Enclosure 7 to E-54692

**CoC 1042 Amendment 2, Revision 1
UFSAR Changed Pages**

Figure B.1-1
Optional Adapter Ring to Dock the OS197 TC loaded with the 61BTH Type 2 DSC with the HSM-MX

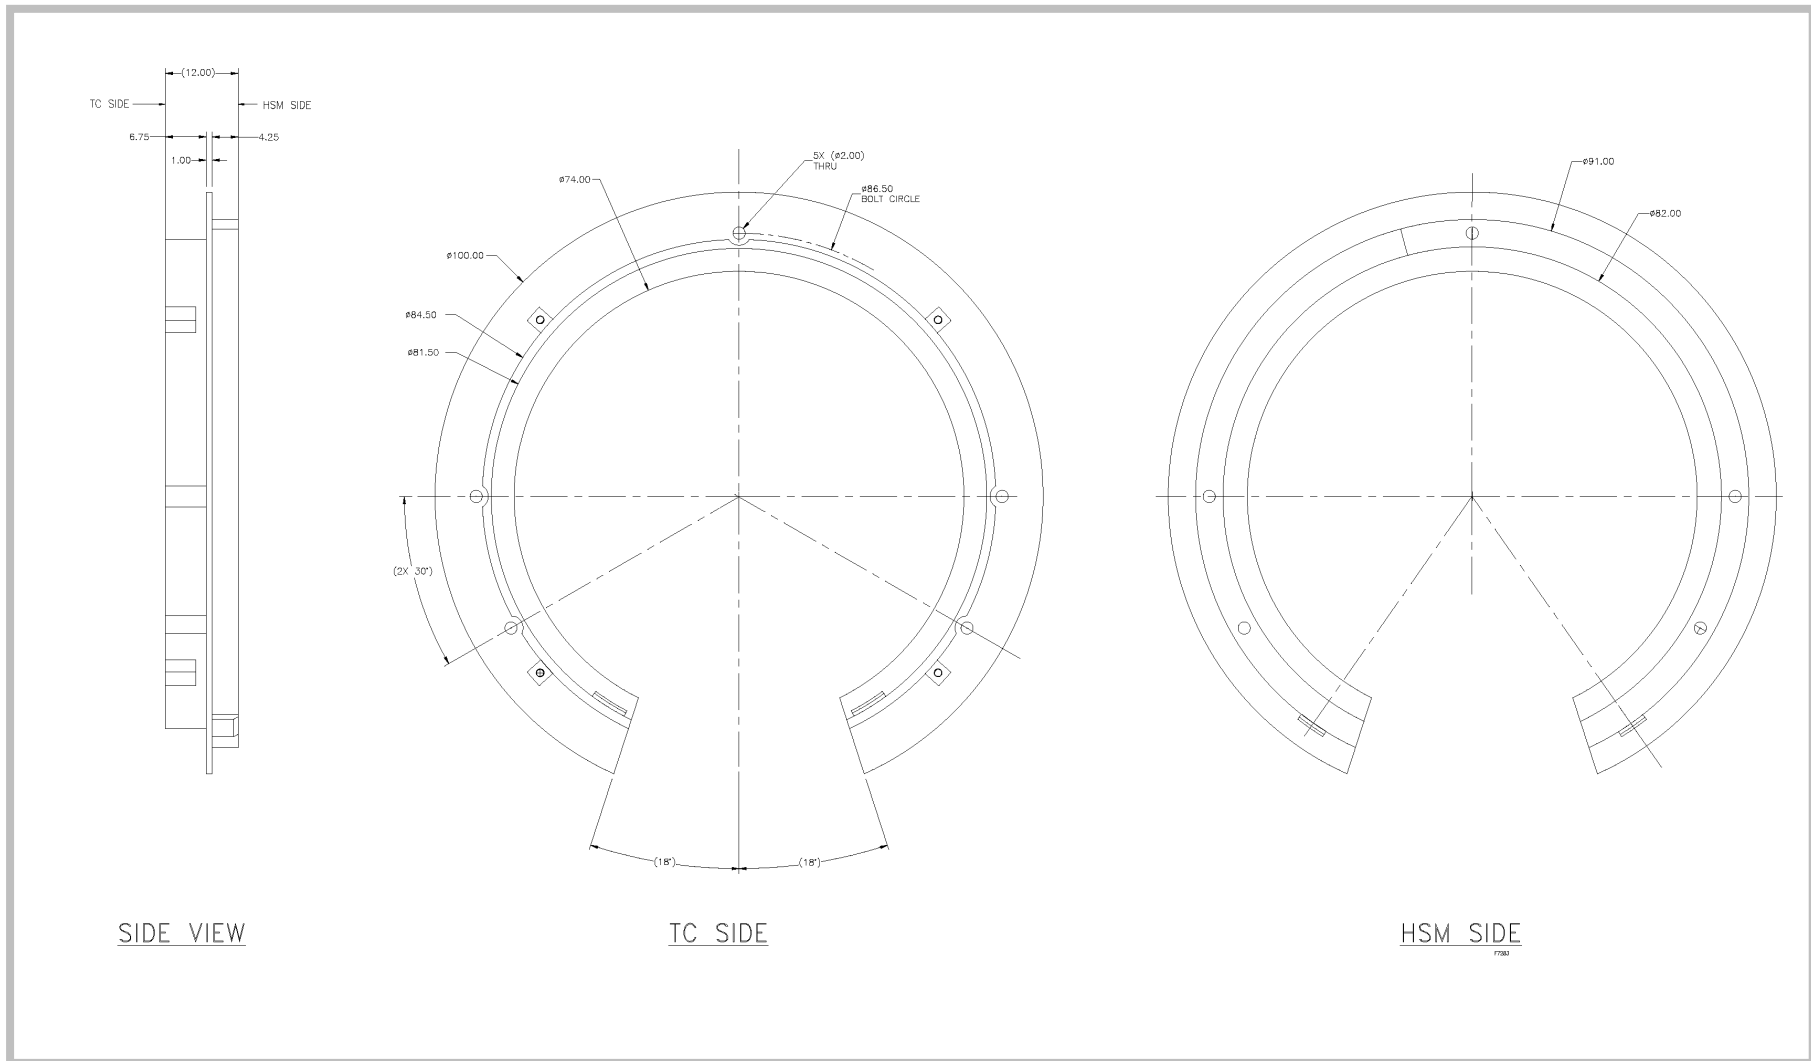
To account for the difference between the OS197 top flange diameter and the EOS-TC diameter, an HSM-MX transfer cask (TC) adapter may be mounted to the door recess of the HSM-MX, *see Figure B.1-1. The adapter interface is designed mainly to aid in TC/HSM alignment as well as protect workers from radiation shielding between the OS197 and the HSM-MX door opening during transfer operations.* Dose rates and occupational exposure in Chapter B.6 and Chapter B.11 are reported without the HSM-MX TC adapter; therefore, the use of this item is mainly for *alignment and* ALARA purposes.
